# **MORGAN AND MORECAMBE OFFSHORE WIND FARMS: TRANSMISSION ASSETS**

**Annex 3.2.18 to Response to RR -Newton with Clifton Parish Council (RR-1616)**

**Document Reference: S\_PD\_3.2.18**

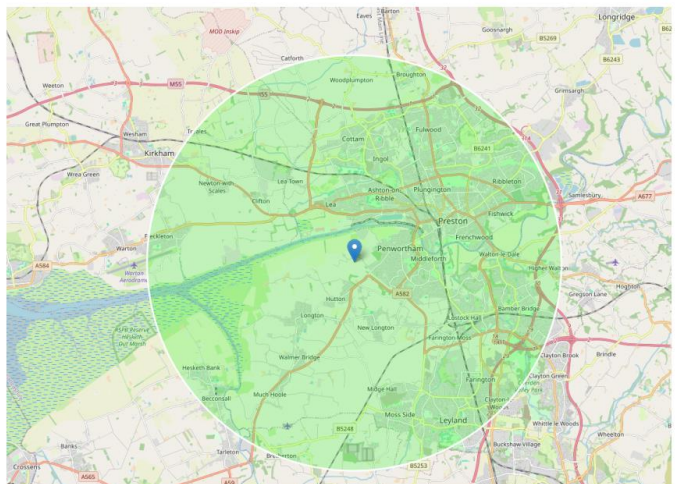
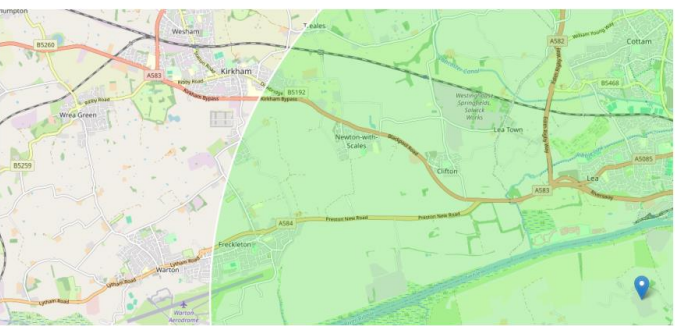
RR-1616 1616.3	<p>1.2 A significant portion of the proposed route for the underground cabling and the Morgan and Morecambe substations is located within the Green Belt between Freckleton and Kirkham. At paragraph 160, the NPPF provides that 'when located in the Green Belt, elements of many renewable energy projects will comprise inappropriate development', and that where this is the case, 'the developers will need to demonstrate very special circumstances if projects are to proceed'. Paragraph 5.11.20 of NPS EN-1, paragraphs 2.8.57 – 2.8.58 of NPS EN-3, and paragraphs 7.7 -7.8 of the FLDP underline the strict requirement for very special circumstances for using Green Belt land. The Applicant has failed to clearly demonstrate how the Project's location of onshore transmission assets in Green Belt land qualifies as 'very special circumstances', particularly as it has failed to provided evidence of consideration of brownfield sites or alternatives. If a diligent consideration exercise had been conducted, the Applicant would have considered the use of already provided industrial</p>	<p>Please refer to the Applicants' response to 1616.2.</p>
